SQM lens comparisons

Half-ball vs cone, IR filters, lens holders

Illustration 4

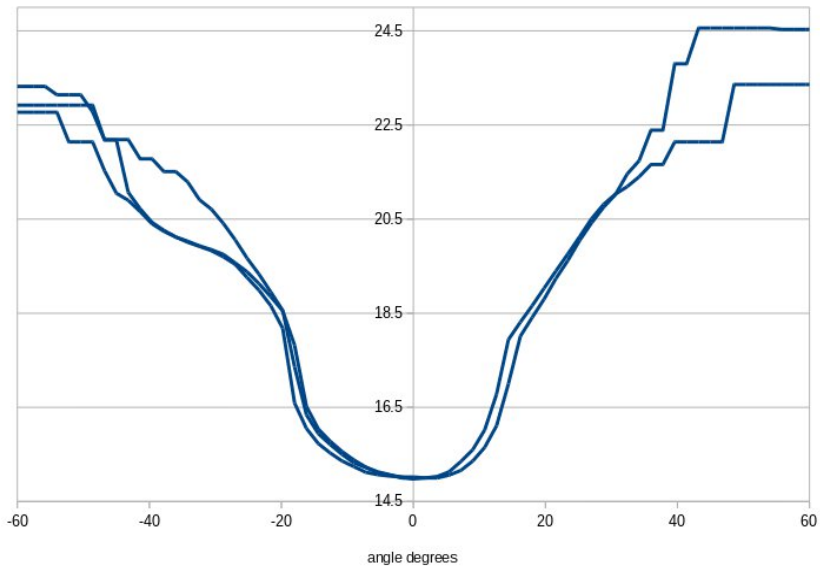
Due to light leakages in the original Golden Dragon (GD) lens and holder, a new (BK7 half ball) lens and (UVIR650) IRfilter design was made in 2013 and introduced in the SQM-LU-DL-V model in 2015. This design is intended to maintain a similar field of view and spectral response with the added benefit of reducing IR leakage around the lens and into the sensor.

SQM-LU with new filter and halfball lens

Illustration 5

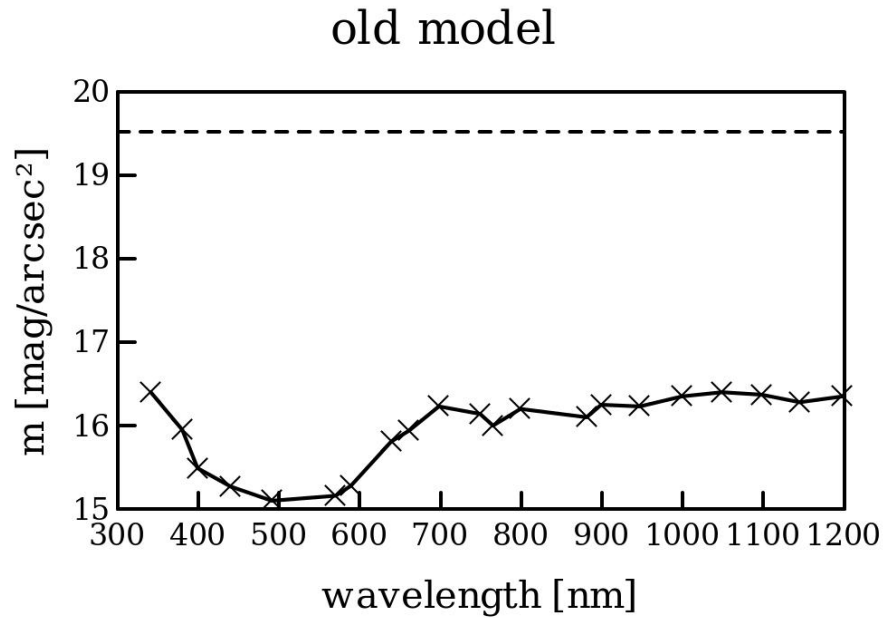
Some preliminary tests performed by Dr. Mauro Pravettoni of SUPSI, Switzerland show the different spectral profile. I suspect that the scaling is due to the test setup since both "old" (HOYA CM500 with GD lens) and "new" (half-ball lens with UVIR650 filter) have been calibrated to the same reading.

The new filter (UVIR650) contains 2-3 micron red leak, but the Si detector has absolutely no sensitivity there.

The main effect of this new IR filter will be increased throughput in the 600-650nm region. The effect of that on readings will depend on the mix of illuminants.
